## **AUTO SHREDDING SUBDIVISION**

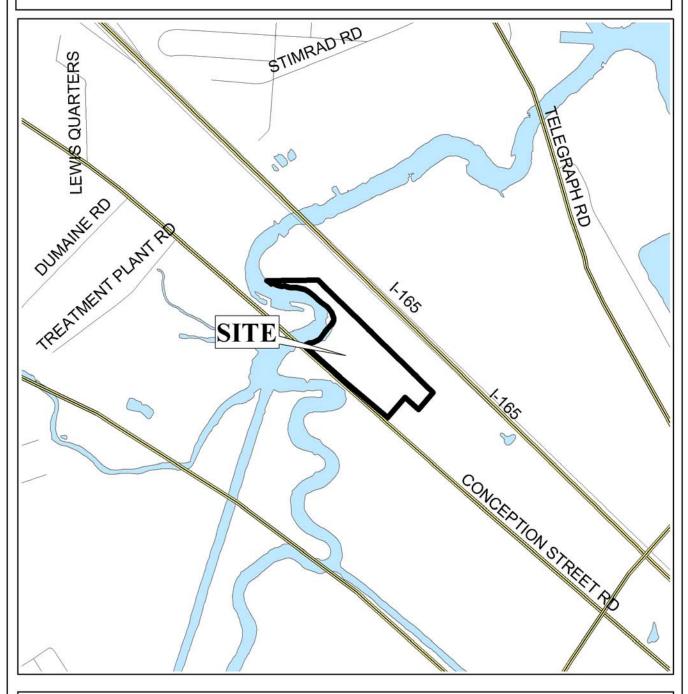
The plat illustrates the proposed 12.2± acre, 2-lot subdivision which is located on the north side of Conception Street Road at Three Mile Creek and is in Council District 2. The site is served by public water and sanitary sewer.

The purpose of the application is to create a two-lot subdivision from two metes and bounds parcels. The plat does not appear to include the entire parent parcel however; southeast of the site is a parcel, created in 1978, after the Subdivision Regulations went into effect. This parcel should be included in the application, with the owner's consent, and additional notice and application fees.

The plat shows a number of existing buildings on the site. Before the final plat is recorded, an application for an Administrative Planned Unit Development should be reviewed and approved by Urban Development.

Based on the preceding, the application is recommended for Holdover until the October 20<sup>th</sup> meeting, to allow the applicant to include the entire parent parcel in the application, and to revise the plat to include a finished floor elevation, and a drainage easement (if any portion of the property conveys stormwater runoff from COM rights-of-way). Revisions should be received by Urban Development by September 26<sup>th</sup>.
